**PROJECT: Lakewood Elementary School
Kitchen Renovation and Freezer Installation**

ADDENDUM 2

Revision to **Construction Documents**
ISSUE DATE: March 28, 2023

CEILING PLAN

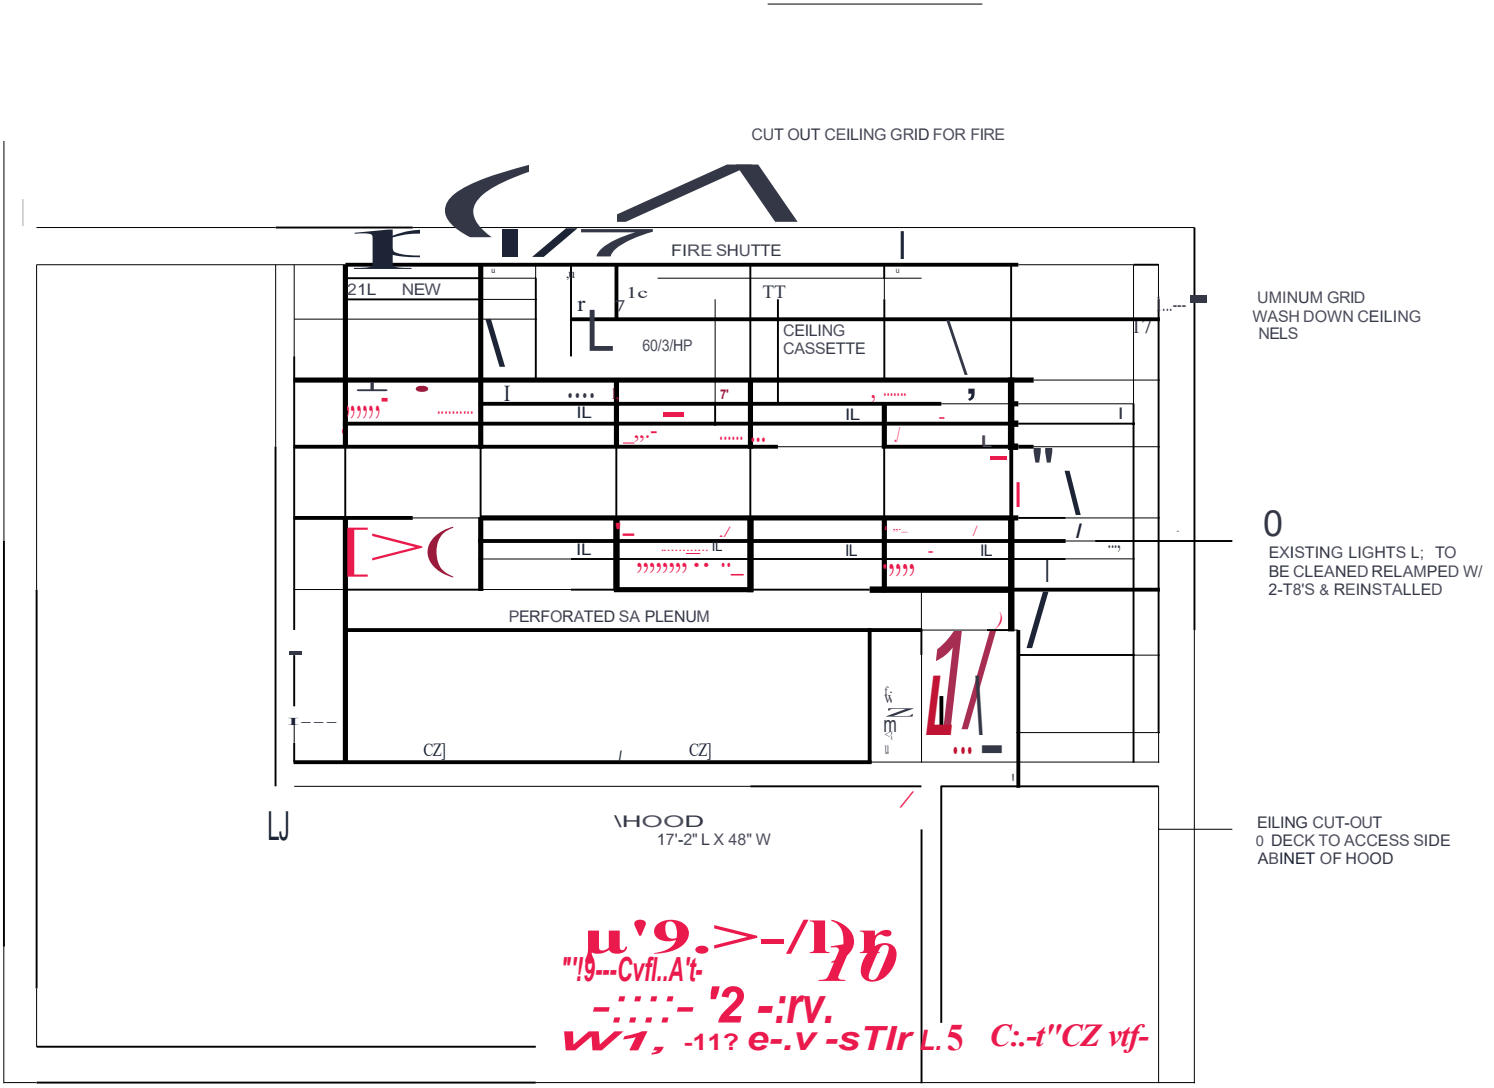
LAW ENFORCEMENT
 ADDRESS ONLY #1.
 MARCH 24 2023

Handwritten notes in red:
 1-A-1'-t... LED5
 I,... IA CJf>> 4-
 Ga:v U,1 tE> \:..
 A.I'Z.. M'1-4 le> , l,v\Yoc;C

Handwritten notes in red:
 V [t>d
 24, 2023
